Form C-103

WELL API NO. 30-025-26773	
5. Indicate Type of Lease STATE ☒ FEE ☐	
6. State Oil & Gas Lease No.	
7. Lease Name or Unit Agreement Name HALE STATE	
8. Well Number 001Y	
9. OGRID Number 329772	
10. Pool name or Wildcat MIDWAY: DEVONIAN	
SUNDRY NOTICES AND REPORTS ON WELLS (DO NOT USE THIS FORM FOR PROPOSALS TO DRILL OR TO DEEPEN OR PLUG BACK TO A DIFFERENT RESERVOIR. USE "APPLICATION FOR PERMIT" (FORM C-101) FOR SUCH PROPOSALS.)	
1. Type of Well: Oil Well ☒ Gas Well ☐ Other ☐	
2. Name of Operator COPPER RIDGE RESOURCES, LLC	
3. Address of Operator PO BOX 519, TUSCOLA, TX 79562	
4. Well Location Unit Letter J : 2260 feet from the south line and 1650 feet from the east line Section 8 Township 17S Range 37E NMPM LEA County	
11. Elevation (Show whether DR, RKB, RT, GR, etc.) 3781 GR

Plugging Plan
Copper Ridge Resources, LLC
Hale State 001Y
API 30-025-26773

BEFORE

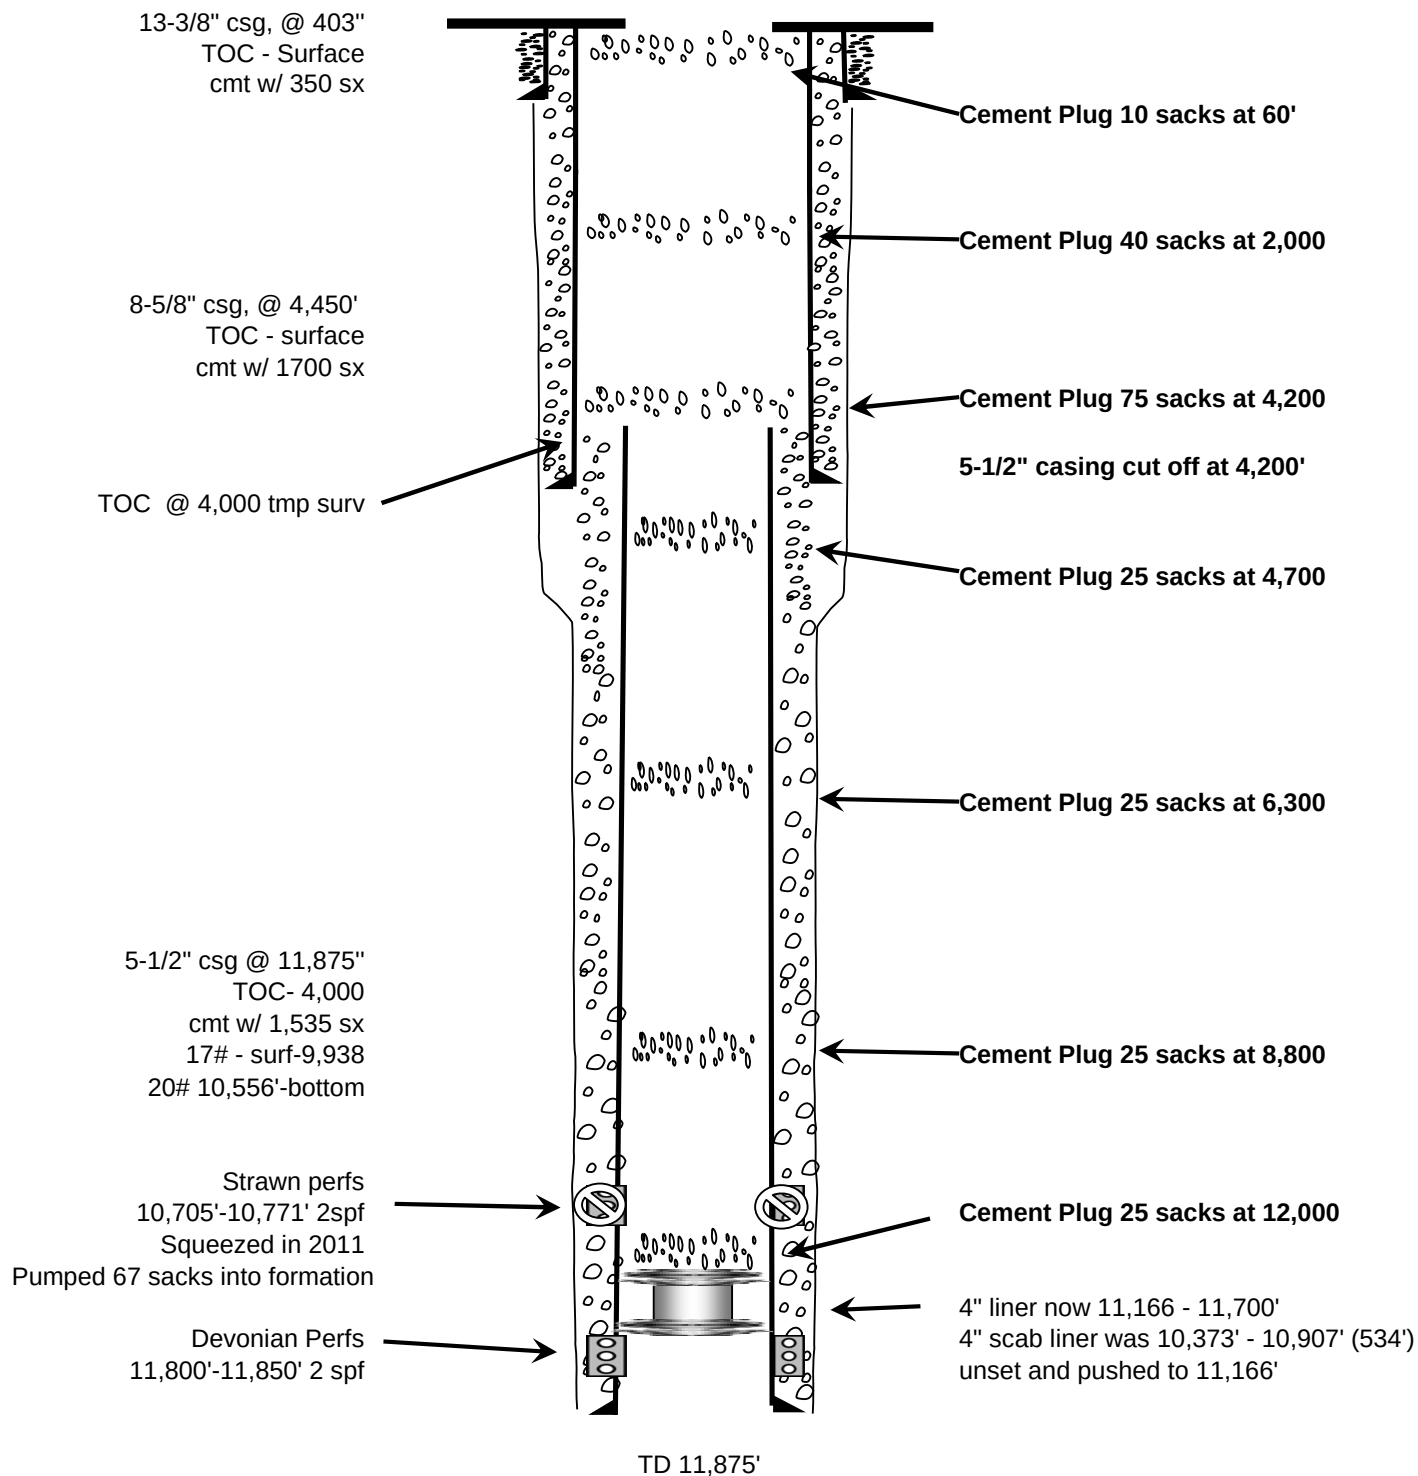
See changes to Plugging Plan

NEW "2024" COA's

1. MIRU, Unset packer and POOH with sucker rods and 2-7/8 tubing.
2. Run in hole with tubing to 11,100, pump 90 sx cl H cmt to bottom - WOC & tag
3. Set CIBP @ 11150' - test casing 500psi/30min - bubble check - Run CBL - circulate 9.5 ppg salt mud to surface.

4. Spot a 25 sack cement plug at 11,100-10,920. WOC & Tag
5. Spot 25 sx cl H cmt 10830' - 10650' - WOC & Tag - Squeeze perfs
6. Spot a 25 sack cement plug from 8800 to 8619.

7. Spot 25 sx Cl H cmt 7615' - 7500' - T Tubb
8. Spot 25 sx cmt @ 6840' - 6710' - T Glorieta
9. Spot a 25 sack cement plug from 6300 to 6119'
10. Spot a 25 sack cement plug from 4,900 to 4,719. POOH with tubing.

11. Nipple down wellhead, cut 5-1/2" casing at 3,900' lay down 5-1/2" casing.
- 12.
13. RIH with tubing to 3900' and spot 75 sack Class C cement plug at 3900' to 3688'. tag this plug - Run CBL

14. Spot 35 sx cmt 3190 - 3090' - T Yates
15. Spot a 35 sack cement plug at 2060 to 1960' - B Salt
16. Spot 35 sx cmt @ 700' - 600' - T Salt
17. Spot a 60 sack cement plug at 200 feet.

18. Rig down plugging equipment.
19. Cut off casing and cap with steel plate and dry hole marker. Clean and reclaim location.
20. Verify cmt to surface on all casings
